UNITED STATES PATENT AND TRADEMARK OFFICE

APPLICATION NO.	FILING DATE	FIRST NAMED INVENTOR	ATTORNEY DOCKET NO.	CONFIRMATION NO.
10/054,517	11/13/2001	Miksa Marton	04004.003	4778

Office Action Summary	Application No.	Applicant(s)
	10/054,517	MARTON, MIKSA
	Examiner Hadi Shakeri	Art Unit 3723

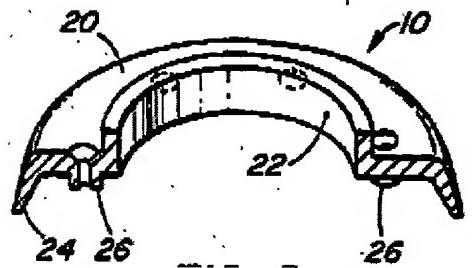
6. Claim 1 is rejected under 35 U.S.C. 102(b) as being anticipated by Marton, US Patent No. 4,616,449.

Marton discloses all the limitations of claim 1, i.e., a suction ring (10) disposed between a sanding pad assembly (12) and the suction housing (14) comprising a circumferential sidewall including

first and second edges, one defining an opening and adapted to mount to the pad assembly (26); a circular back wall, being continuous with the other of the edges

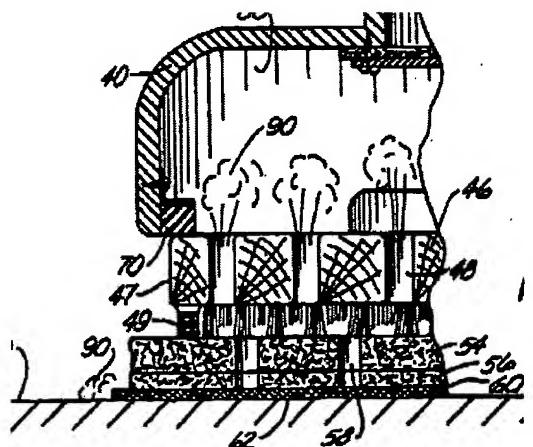
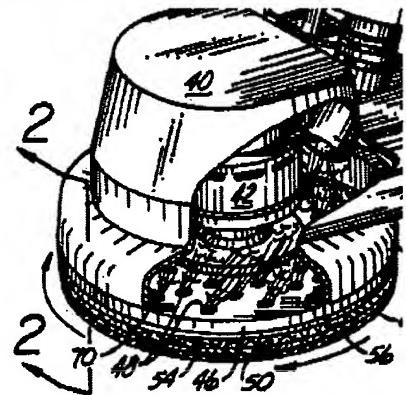
8. Claim 1 is rejected under 35 U.S.C. 102(b) as anticipated by or, in the alternative, under 35 U.S.C. 103(a) as obvious over Takashima, US Patent No. 5,027,470.

Takashima discloses all the limitations of claim 1, i.e., a suction ring (lower part of 40) disposed between a sanding pad assembly (44) (52), and the suction housing (upper part of 40 surrounding the motor) comprising a circumferential sidewall including first and second edges, one defining an opening (sealed by 70), and adapted to mount to the pad assembly, i.e., (44); a circular back wall (lower part meeting the upper part), being continuous with the other of the edges, since rotatable shaft with an off-set portion as recited in the preamble is not linked into the body of the claim, Takashima is considered to meet all the limitations of claim 1, however, in the alternative the housing and structures of the invention of Takashima in an off-center shaft, e.g., orbital sander, depending on the intended

use and/or operational parameters, modification within the knowledge of one of ordinary skill in the art, would meet all the limitations of the claim.

Regarding claim 3, Takashima discloses the claimed invention except for the use of the specific materials. It would have been obvious to one having ordinary skill in the art at the time the invention was made to aluminum for its desired properties, e.g., light weight, since it has been held to be within the general skill of a worker in the art to select a known material on the basis of its suitability for the intended use as a matter of obvious design choice. *In re Leshin*, 125 USPQ 416.

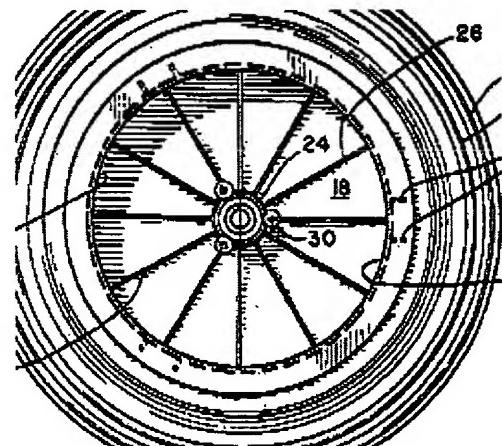
9. Claim 2 is rejected under 35 U.S.C. 103(a) as being unpatentable over Takashima in view of Kitahata, US Patent No. 5,172,448.

Takashima meets all the limitations of claim 2, except for ribs radially disposed and extending from the sidewall to the like plurality of legs. Kitahata teaches buffer pad assembly having a plate (18) reinforced with radially extending ribs (26). It would have been obvious to one of ordinary skill in the art, at the time the invention was made, to modify the invention of Takashima with reinforcing ribs as taught by Kitahata to stiffen the ring, e.g., in application wherein a weaker material is used for the housing, e.g., syntactic resin, aluminum...depending on the operational and/or cost parameters.
